## PLAN COMMISSION

September 10, 2019

**Proposal:** Plan Review – Screening Modifications for Edgewood Elementary School

**Proposal:** Plan Review – Site, Landscaping, and Screening Modifications for Meadowview Elementary School

DRAWING NUMBER  
**M401**  
EES  
© Nexus Solutions, LLC

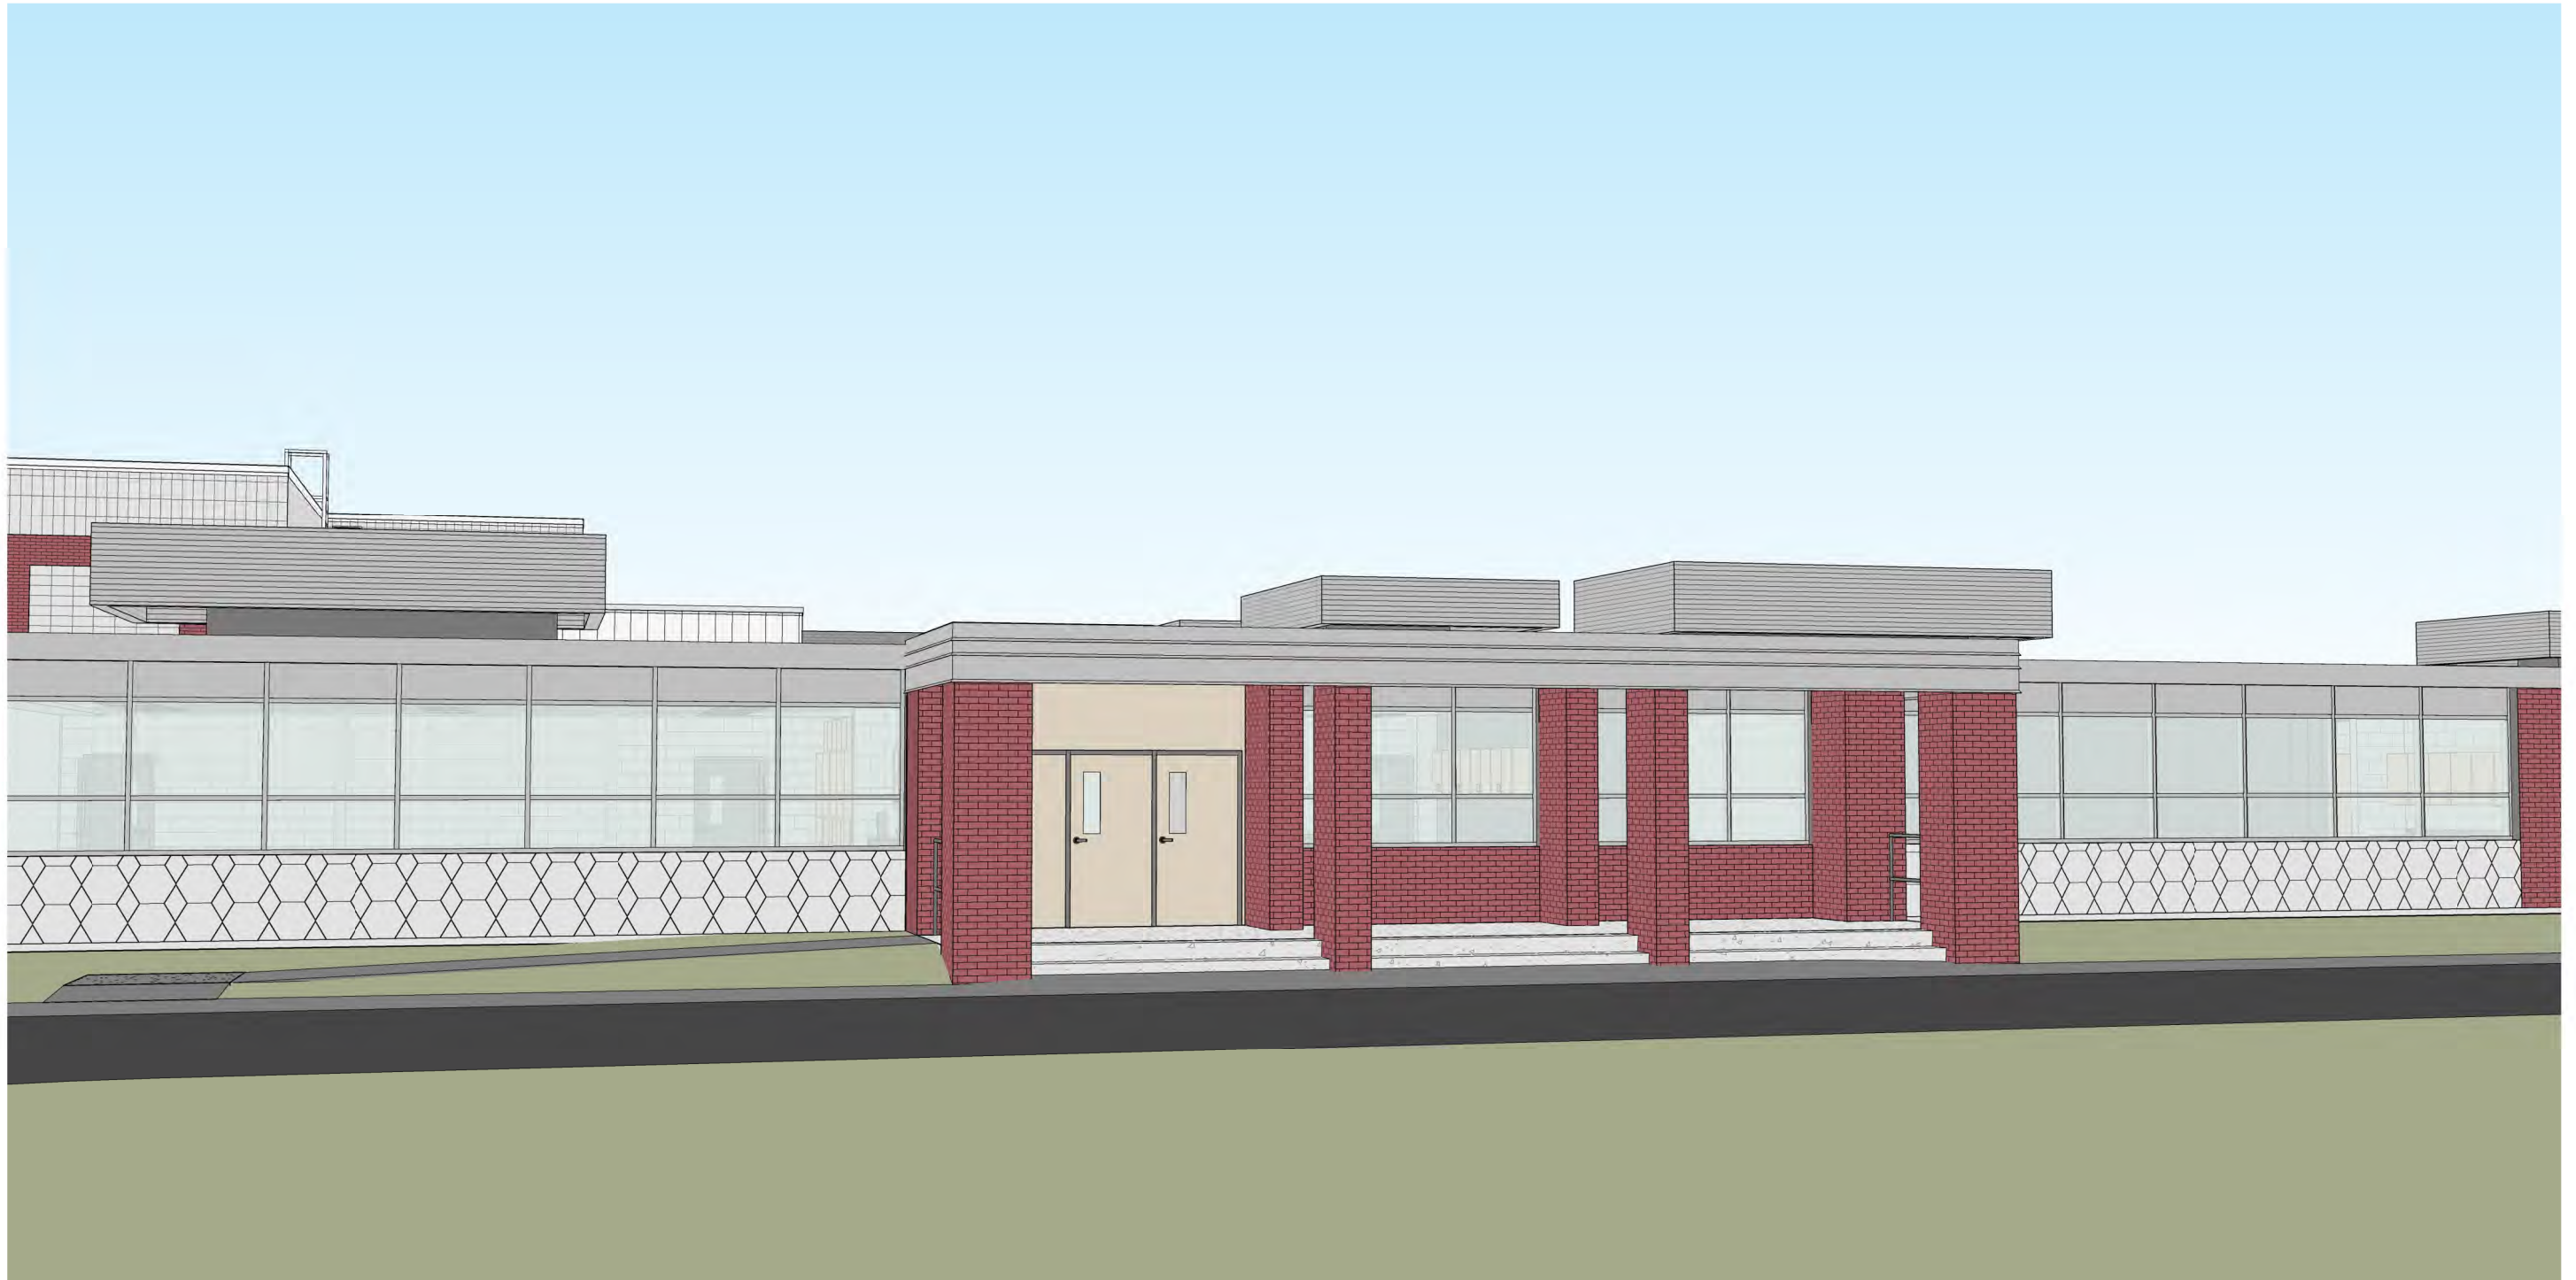
At the March 12, 2019 meeting, the Plan Commission approved site plans for modifications to the existing parking areas and internal drives, new parking areas, and an addition for a new gymnasium for Edgewood Elementary School at 8545 S. Shepard Ave. Plan Commissioners may recall that existing rooftop mechanical units (RTUs), which are not currently screened, were to be replaced with larger RTUs. Per Section 17.1010(g) of the Municipal Code, “roof mounted mechanical equipment shall be screened from casual view.” The Applicant is requesting a modification to remove this requirement from the plans.

While staff can appreciate that the existing RTUs have not historically been screened, any change to the existing conditions requires conformance with Code. This is true for any site or building modification within the City. Staff disagrees with the assessment in the submitted narrative that screening will make the RTUs more visible from the road, and that screening will be less aesthetically pleasing than exposed RTUs. Rather, screening as included in the submitted examples and throughout the City generally have the effect of blending with the architecture of the building. Those structures that do not incorporate RTU screening are more visible from the road, and are the examples of why the Code requires screening. Staff have consistently included in Conditions of Approval for Plan Commission consideration that all mechanical equipment, transformers, and utility boxes (ground, building, and rooftop) are screened from view per Code requirements, including in this case.

- Existing RTU being replaced was: 58" w x 88" l x 50" h on top of ~12" curb.
- New RERVU is: 95" w x 128" l x 50" h on top of 14" curb. The unit is longer due to energy recovery and wider due to DX cooling module.
- With the RERVU having a housing dimension of 58" w x 128" l x 50" h (not including DX module and outdoor hood), adding screening results in: 154" w x 224" l x 50" h. Therefore the screening will add 59" of obstructed view at this unit.
- Other locations we're combining existing RTU to single RERVU or moving existing roof edge located RTU away from edge
- Adding screening to RTU's on this building will add a total of 8' of obstructed view to the roof of the building.

1. That all relevant Code requirements remain in effect.
2. That all conditions of approval from March 12, 2019 remain in effect except as specifically amended herein.
3. That the proposed rooftop mechanical units are not required to be screened at this time; however, any changes to the rooftop mechanical units will require screening at the time of installation.
4. That all detailed, revised plans are submitted in digital format to the Department of Community Development prior to submission of permit applications.
